Access Compliance Report

Public Rights-of-Way

(Curb Ramps)

Intersection ID: 10038344	Main Street: SOUTH_BV	Cross Street: N/A	Location: E
ADA ID: DE16DB5E4E2B	Ramp Type: Perp	Initial Pass/Fail: Fail	Overall Compliance: No
Severity Score: 8.75			
Codes/Mitigation Info/Possible Solution		Field Measurements/Component Compliance

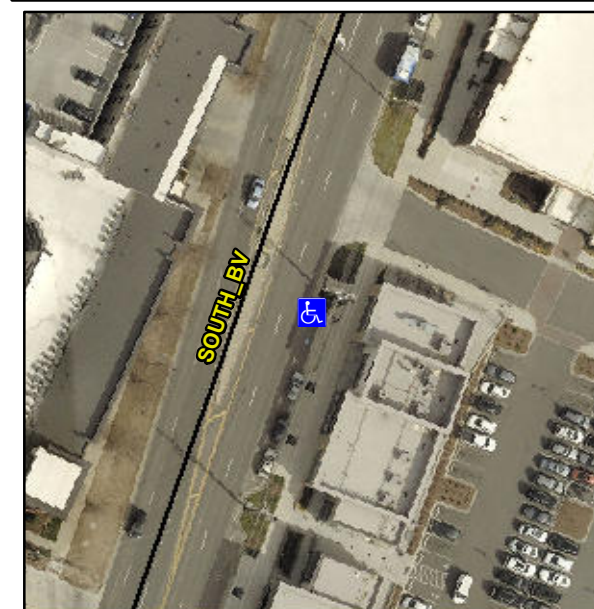
Not Found, R304.5.1

Compliance	Description	Data	Compliance	Description	Data
N/A	Ramp Length (in)	62.5	Yes	Ramp Slope (%)	7.2
No	Ramp Width (in)	46.0	Yes	Ramp XSlope (%)	1.5
N/A	Flare Type LT	N/A	N/A	Flare Type RT	N/A
N/A	Flare Slope LT (%)	N/A	N/A	Flare Slope RT (%)	N/A
N/A	Flare Traversable LT?	N/A	N/A	Flare Traversable RT?	N/A
N/A	Landing Length (in)	N/A	N/A	DWS Provided?	N/A
N/A	Landing Width (in)	N/A	N/A	DWS Contrast?	N/A
N/A	Landing Slope (%)	N/A	N/A	DWS Length (in)	N/A
N/A	Landing X Slope (%)	N/A	N/A	DWS Full Width?	N/A
N/A	Landing Curb? (Y/N)	N/A	N/A	DWS Offset (in)	N/A
N/A	Shared Landing?	N/A			
N/A	Gutter Ponding?	N/A	N/A	Gutter Slope (%)	N/A
N/A	Gutter Lip Ht (in)	N/A	N/A	Gutter X Slope (%)	N/A
N/A	Painted X Walk1?	No	N/A	Painted X Walk2?	N/A
	X Walk 1 Direction	To NW		X Walk 2 Direction	N/A
N/A	X Walk 1 Width (in)	N/A	N/A	X Walk 2 Width (in)	N/A
	X Walk 1 Slope (%)	0.1		X Walk 2 Slope (%)	N/A
	X Walk 1 X Slope (%)	1.3		X Walk 2 X Slope (%)	N/A

Remove & Replace Entire Ramp.
